Figure 148-4—PLCA Control state diagram (continued)

Figure 148-5—PLCA DATA state diagram (continued)

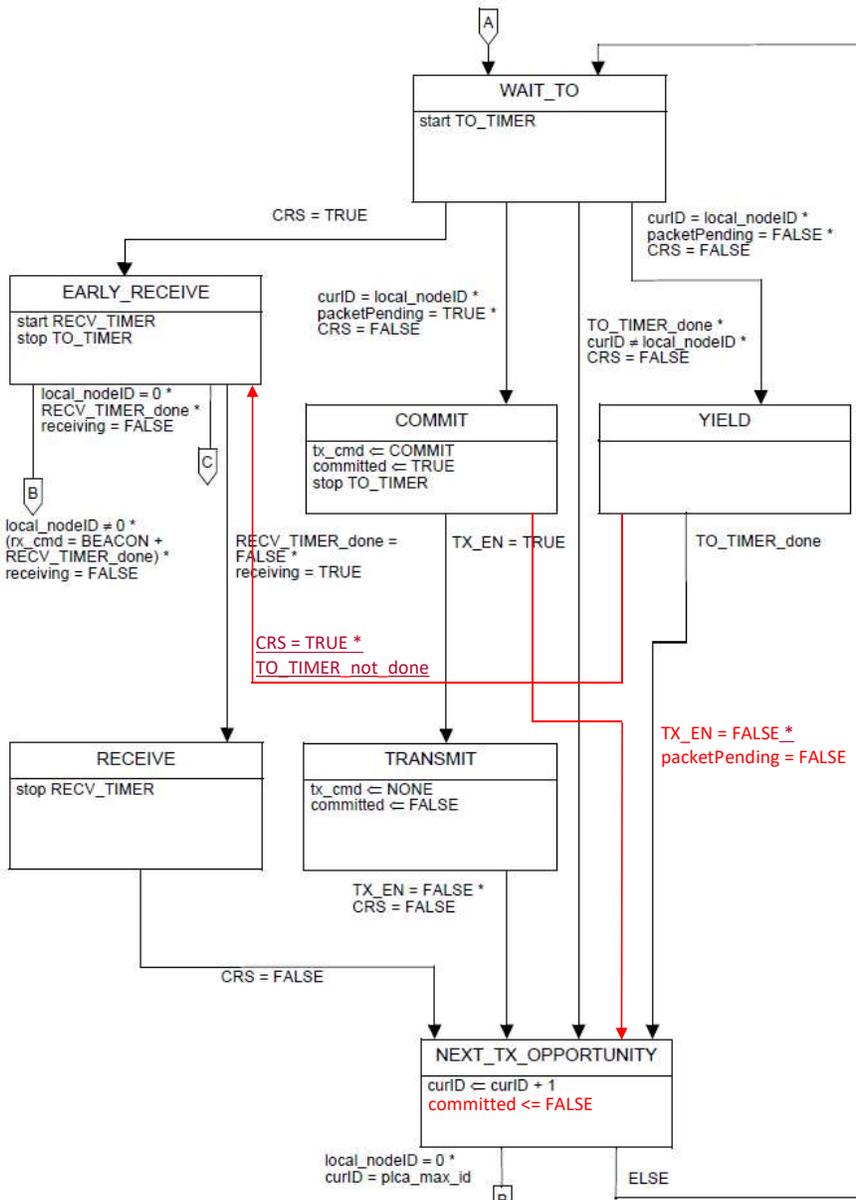
Commented [PB2]: [PLCA\_ROBUST] modify state diagram with editorial license to redraw in compliance with IEEE style rules.

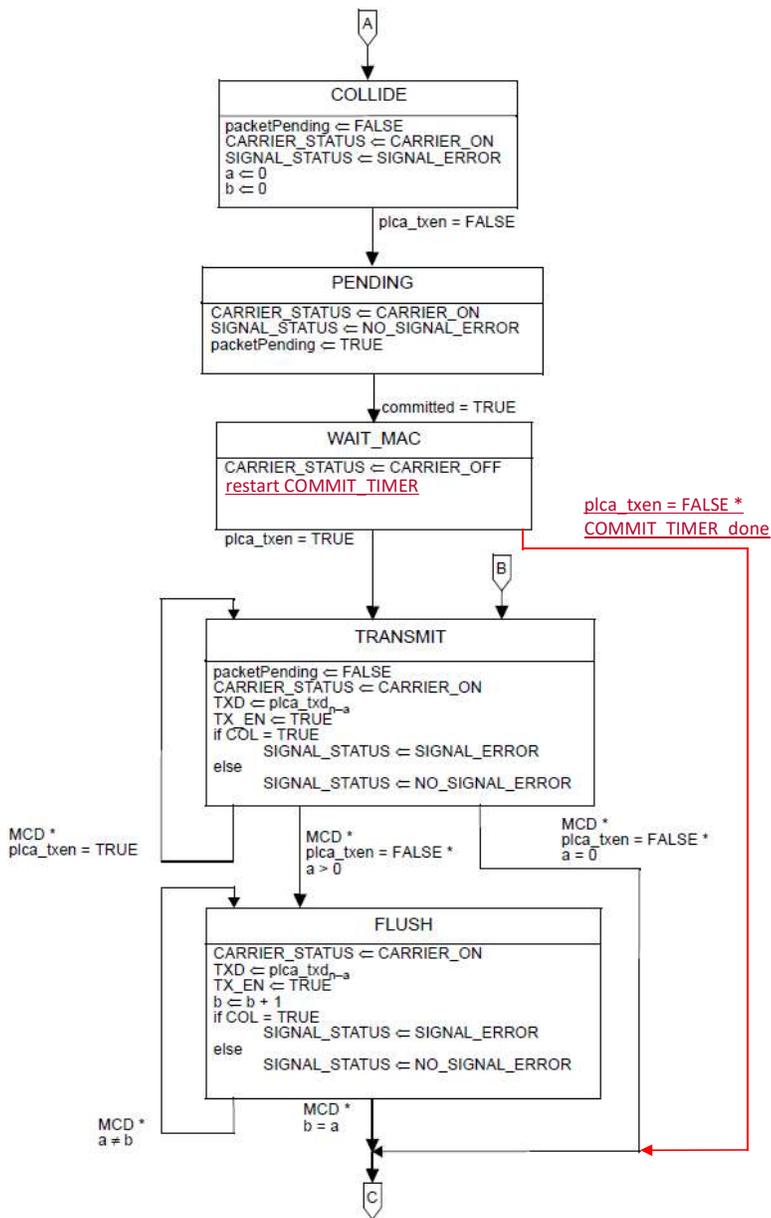
Commented [PB3]: [PLCA\_ROBUST] Change state Diagram

plca\_txen = FALSE \*  
COMMIT\_TIMER done

MCD \*  
plca\_txen = TRUE

MCD \*  
plca\_txen = FALSE \*  
a > 0

MCD \*  
plca\_txen = FALSE \*  
a = 0

MCD \*  
a = b

MCD \*  
b = a

#### COMMIT TIMER:

Define the maximum time the PLCA Data state machine is allowed to stay in WAIT\_MAC\_STATE.

Duration: 288 bit times
